PHASE I INSPECTION REPORT
 NATIONAL DAM SAFETY PROGRAM
 HELDERBERG LAKE DAM I.D. NO. 276
 DEC # 190D-1294 LOWER HUDSON RIVER BASIN
 ALBANY COUNTY

PHASE I INSPECTION REPORT
NATIONAL DAM SAFETY PROGRAM

Name of Dam:	Helderberg Lake Dam(I.D. No. NY 276)
State Located:	New York
County Located:	Albany
Stream:	Onesquethaw Creek
Dates of Inspection:	November 27, 1979, January 25, 1980

Photo #12
Toe of Masonry Wall
Note deterioration & seepage

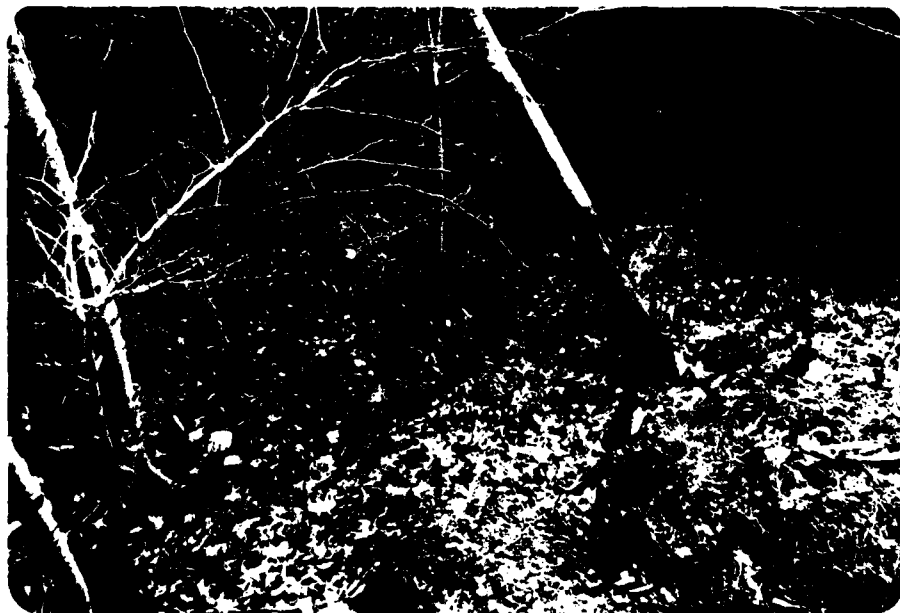
There was a notable flow emanating from the toe of the dam. (See Photo #12) The flow was clear and seemed to come primarily through the collapsed masonry outlet wall (See Photo #11); is assumed to be caused by a leaking valve on the drain pipe, flow is estimated to be 10 to 15 gpm. On both inspection visits to the dam the spillway was flowing, hampering close inspection around the spillway. It appeared to be in good condition although erosion along each side was taking place, apparently from surface runoff. A 2" drain pipe was located along the left spillway channel wall, no flow was emanating at the time of inspection. Seepage was evident on the left side of the spillway (downstream edge) emanating from a crack at the intersection of the spillway wall and the spillway slab. The flow estimated to be less than 10 gpm was clear with no indication of particle migration. It is recommended that further investigation look into seepage around and under the spillway during a period when the spillway is not operating. (See Photos #6 & 7)

The reservoir drain, consisting of a 20" diameter intake pipe, a valve with a stem at the crest of the dam (See Photos #2 & 14), and a concrete and masonry outlet chamber, has not been operated since the 1940's. The outlet chamber is buried beneath backfill at the toe of the dam and the deteriorated masonry wall. (See Photos #9, 11 & 12)
